Model: Russian-C1		Date: 15-Feb-00	No.: RA265002
Subject: Service Manual Correction		Prepared by: S. Tomoe	
From: Technical Services Dept., GTS Division			
Classification:	<input type="checkbox"/> Troubleshooting <input type="checkbox"/> Part information <input type="checkbox"/> Action required <input type="checkbox"/> Mechanical <input type="checkbox"/> Electrical <input type="checkbox"/> Service manual revision <input type="checkbox"/> Paper path <input type="checkbox"/> Transmit/receive <input type="checkbox"/> Retrofit information <input checked="" type="checkbox"/> Other (      )

Please correct your service manuals as follows:

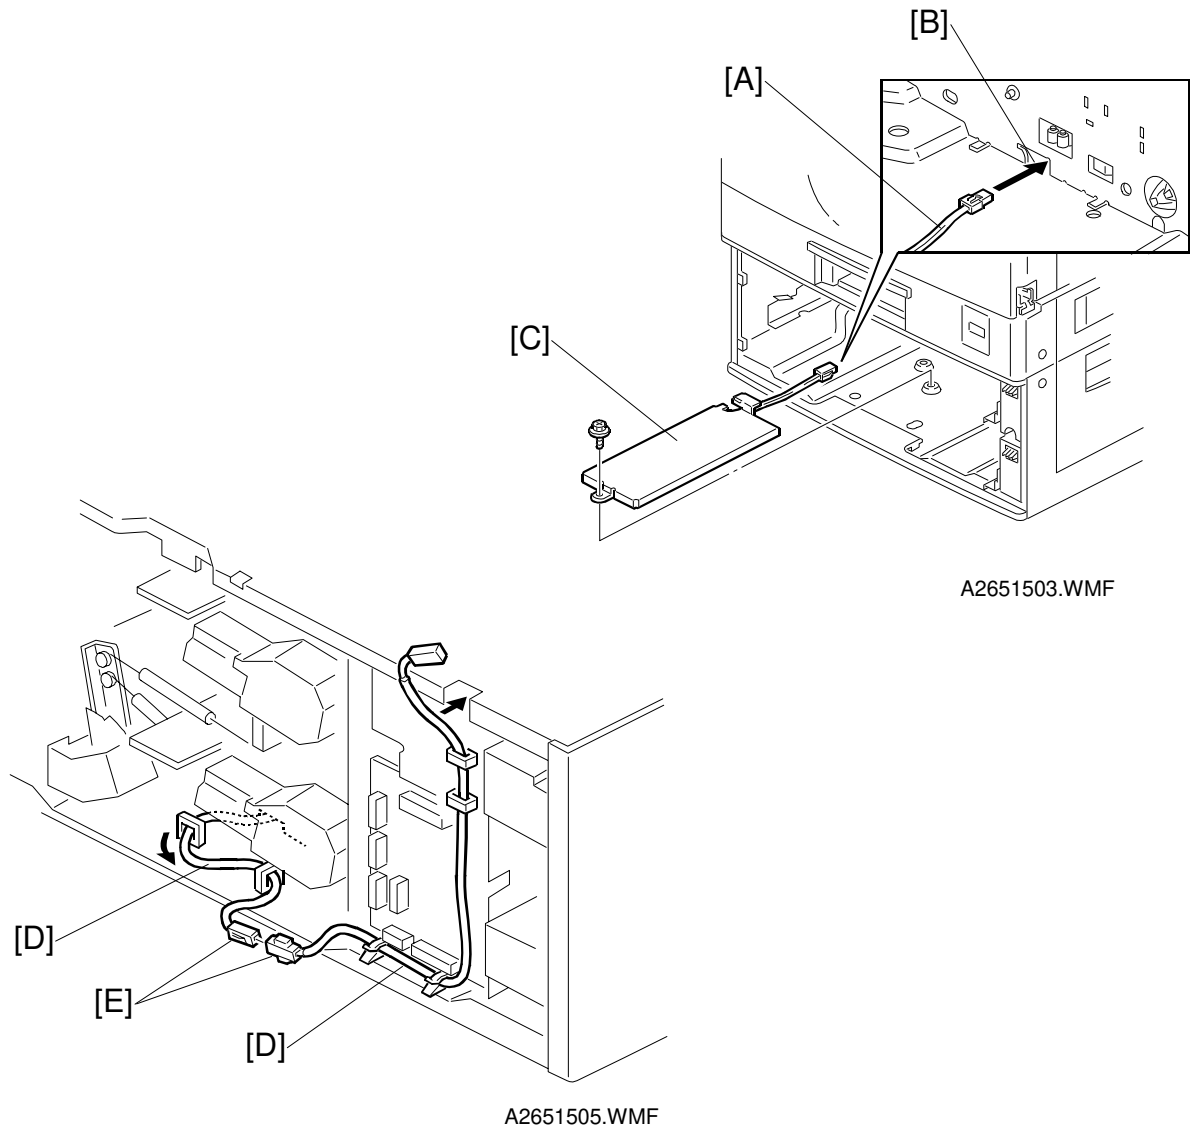
Delete Note no.2: "If this finisher will be installed on the A265 or A267 copier, ..."
